**RE: Luxelocker
Conceptual Grading & Drainage Plan
Engineer's Stamp Date: 07/13/22
Hydrology File: B18D031**

TECHNICAL MEMORANDUM

Re: LuxeLocker
Conceptual Grading & Drainage Plan
Engineer's Stamp Date" 06/03/22
Hydrology File: B18D031

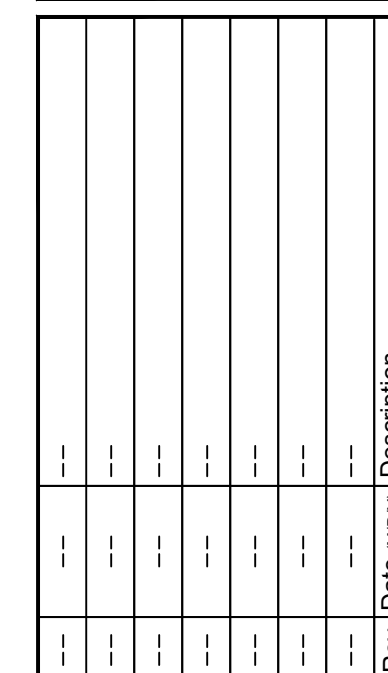
8. The whole grading needs to be revised. The entire site just drains directly to Beverly Hills without going into either of the required stormwater quality ponds as outlined in Comment #6.

Response: Yard inlets have been provided to capture the site runoff and convey it to the proposed stormwater management facilities. These areas are shown on the Grading and Drainage Plan.

POND SECTIONS

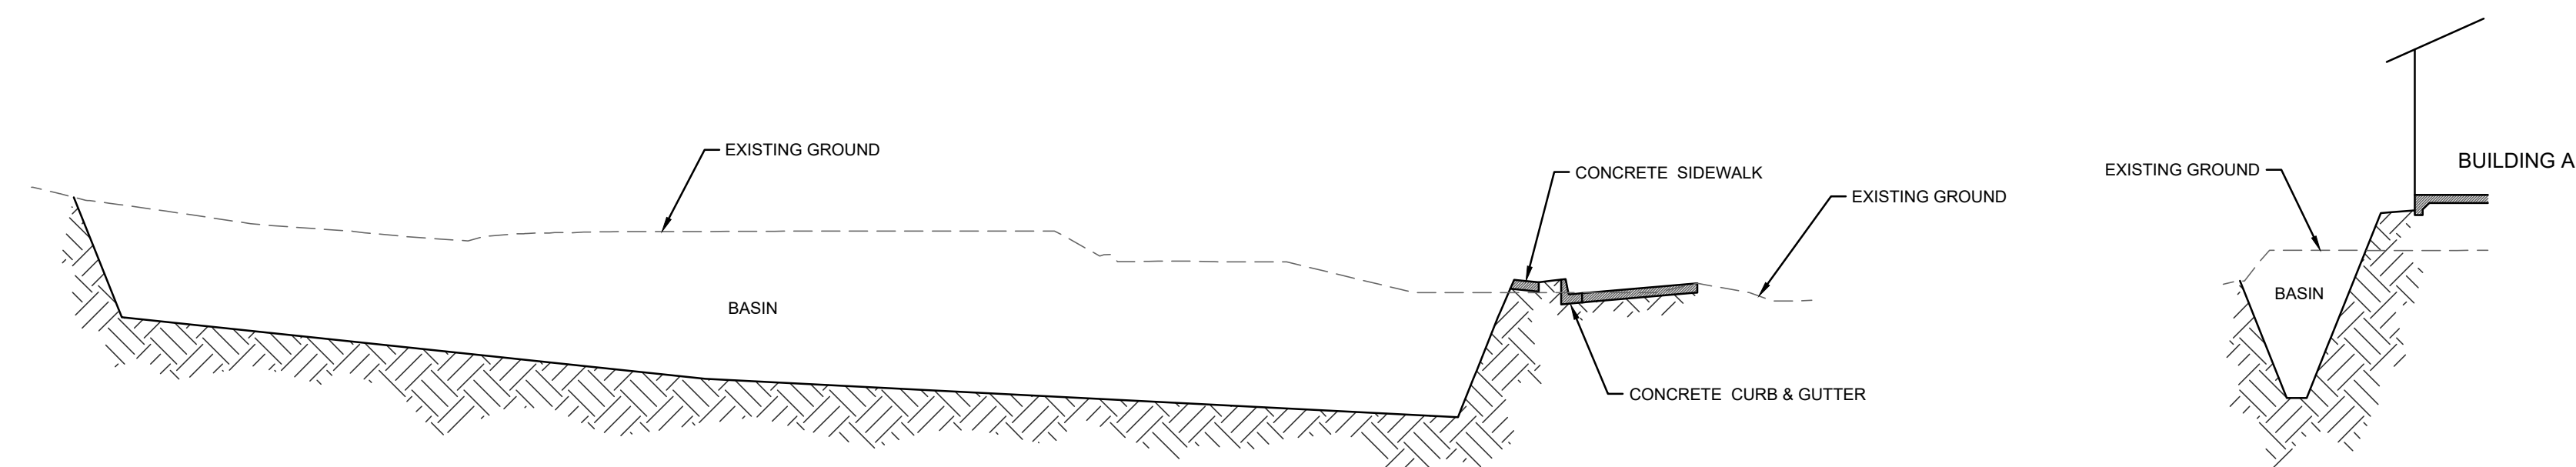
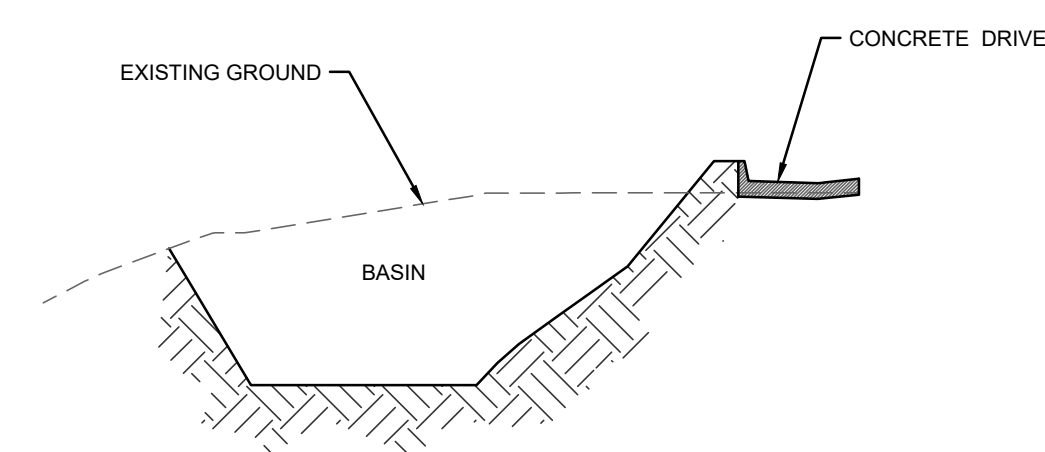
2. Hydrology also does need the Site's Cut & Fill calculation and the overall site sections. Hydrology does need sections through the stormwater quality ponds and through any retaining / garden walls (only if you have them).

Response: The Site's Cut & Fill calculation along with the overall site sections has been removed with this submittal and replaced with the pond sections.

Sheet Title:
DRAINAGE AREA MAP & STORM CALCS.

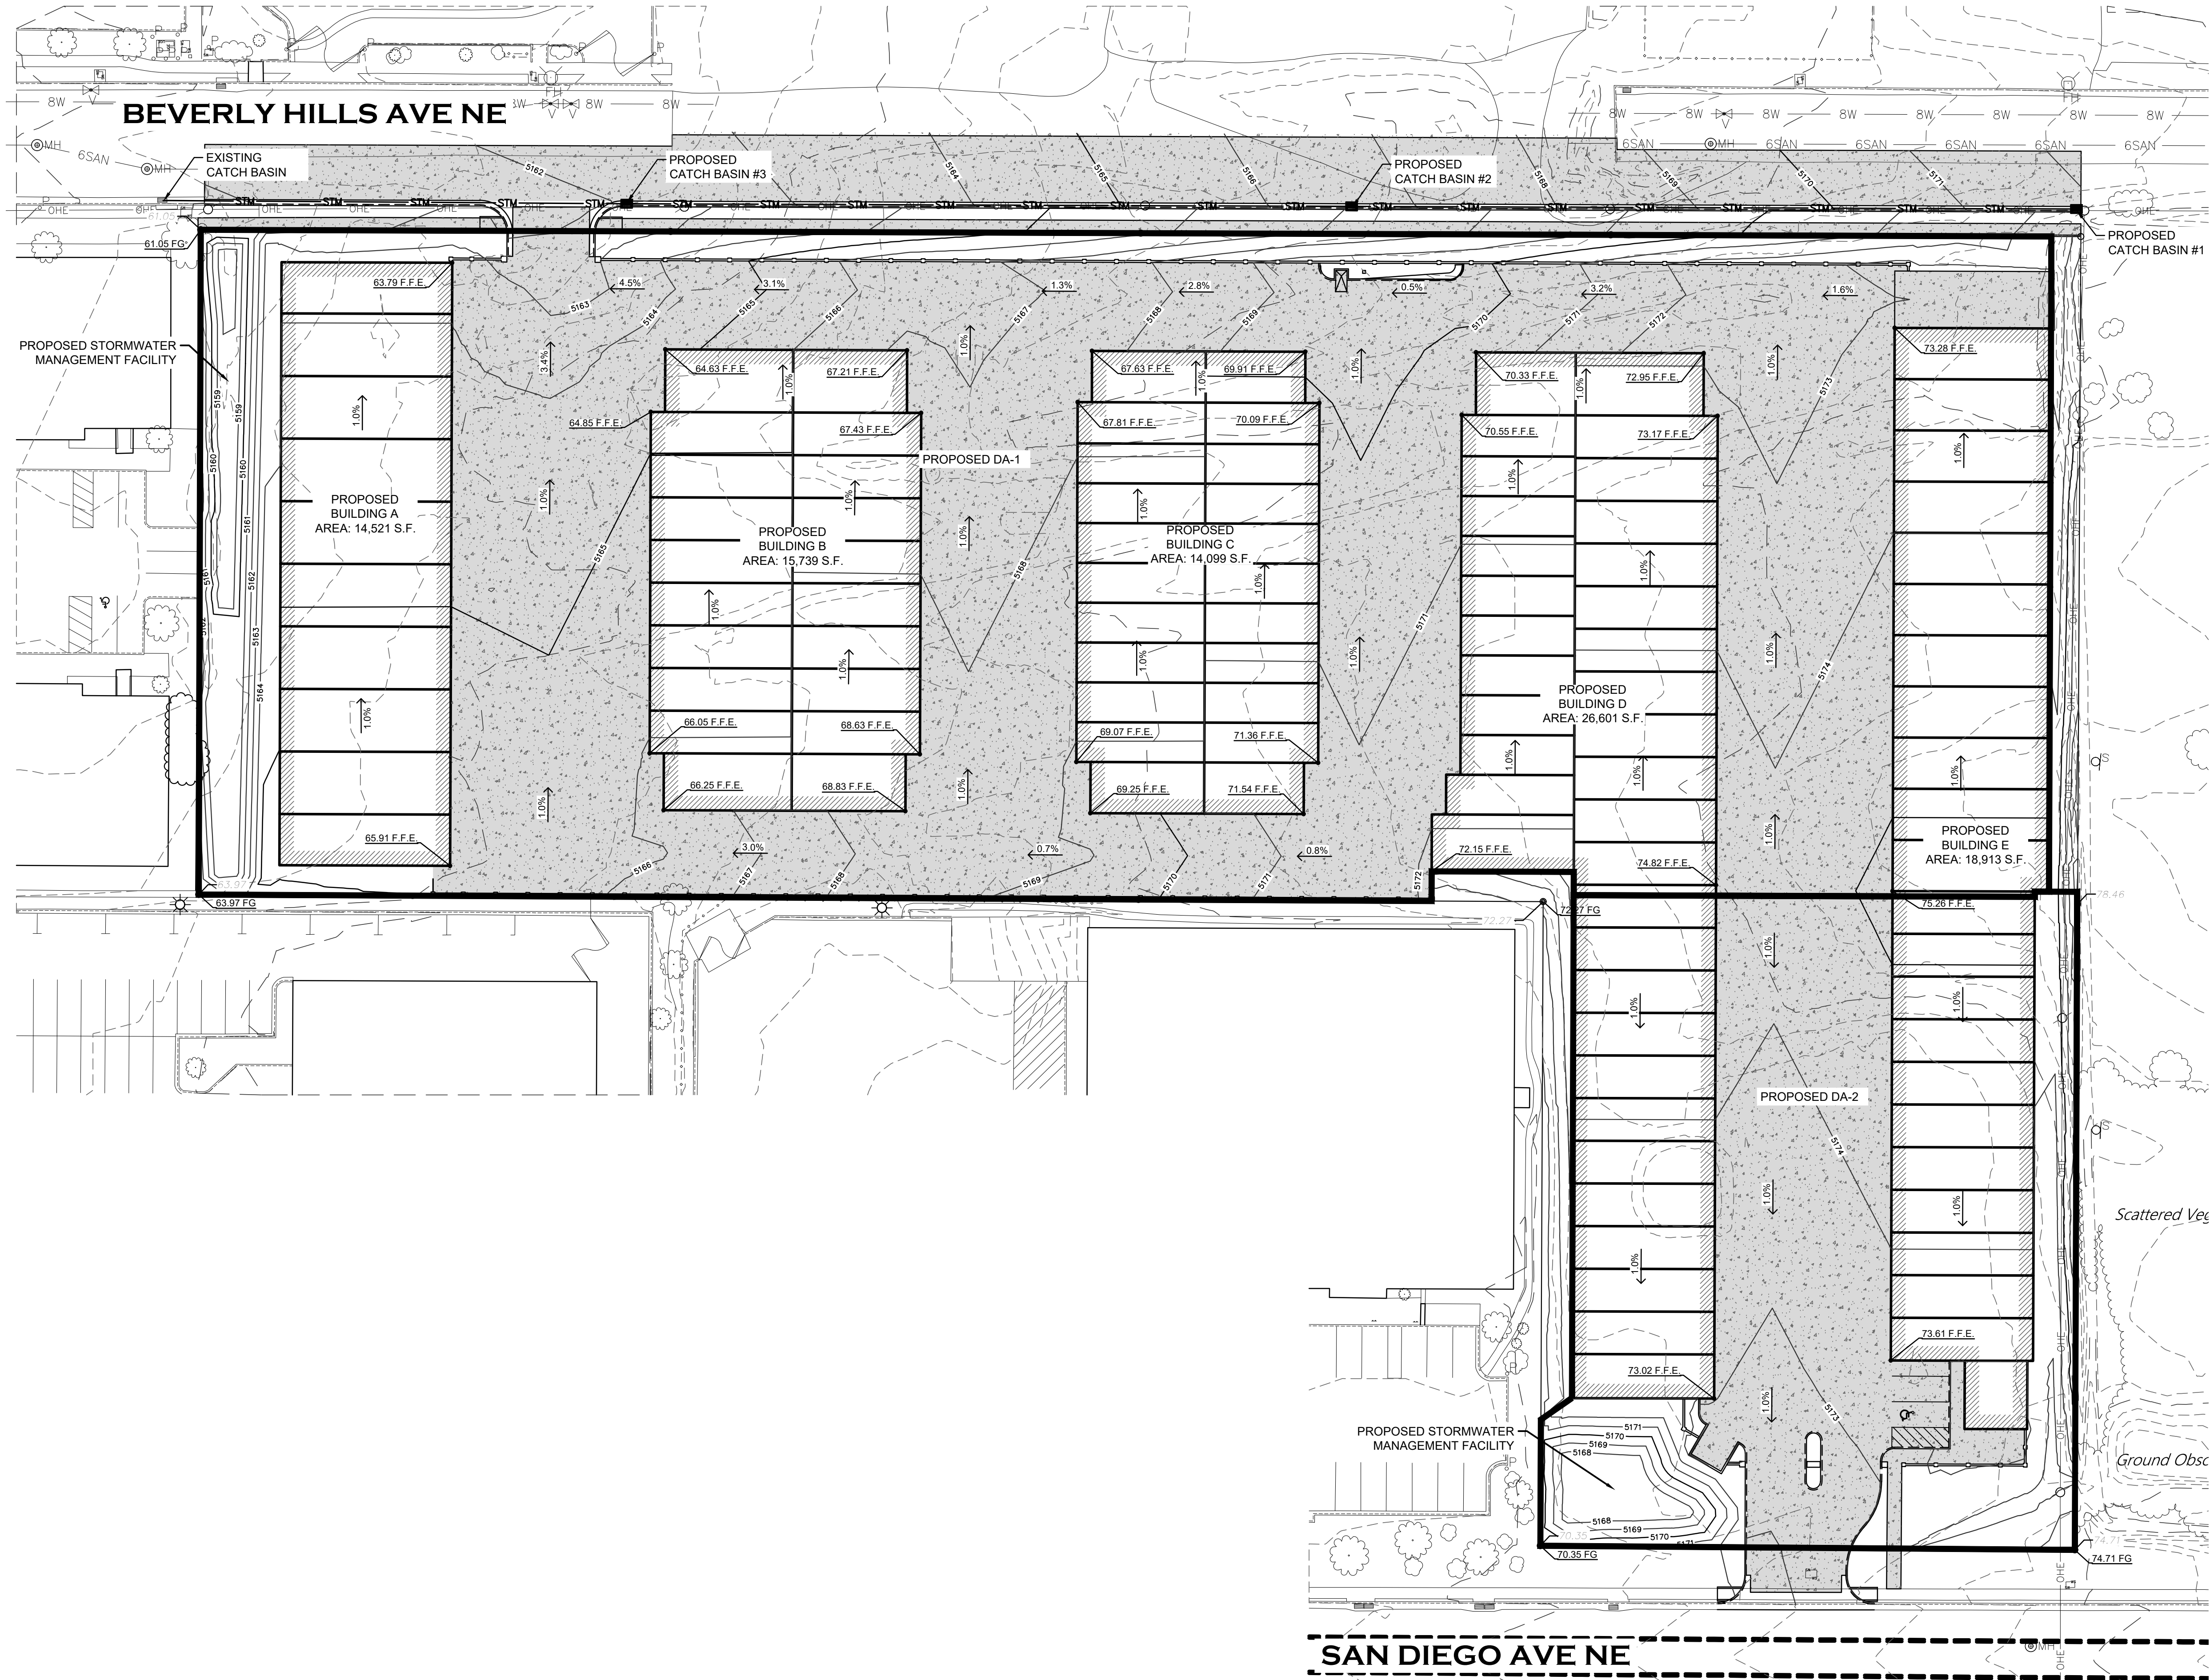
5. Please use the procedure for 40 acre and smaller basins as outlined in Development Process Manual (DPM) Article 6-2(a). Please provide both the existing conditions and proposed conditions for the 100 year – 6 hour storm event.

6. Please follow the DPM Article 6-12 Stormwater Quality and Low-Impact Development for the sizing calculations. To calculate the required SWQV, multiply the impervious area draining to the BMP by 0.42 inches for new development sites. Each stormwater quality pond must have a spillway. This is typically handled by installing a sidewalk culvert with the invert starts at the elevation of the SWQV on the pond side and slopes to the street gutter elevation. Below is an illustration of this.

10. Need to calculate the south half of Beverly Hills street capacity as described in the DPM Article 6-9 Street Hydraulics. If the HGL or EGL is over the proposed top of curb, then an inlet will need to be installed. This inlet will then need to be connected to the existing 36-in storm sewer to the west on Beverly Hills.

Response: Both the existing conditions and proposed conditions for the 100 year – 6 hour storm event has been provided on the Drainage Area Map & Storm Calcs Sheet.

Response: The required and provided SWQV for both ponds have provided on the Drainage Area Map & Storm Calcs Sheet. The sidewalk culverts for both ponds have been shown on the Grading and Drainage Plan.

Response: Street capacity calculations have been provided on the Drainage Area Map & Storm Calcs Sheet. Storm inlets have been provided to reduce the runoff within Beverly Hills, so the 100-year storm event does not overtop the curb. The proposed inlets are shown on the Grading and Drainage Plan.
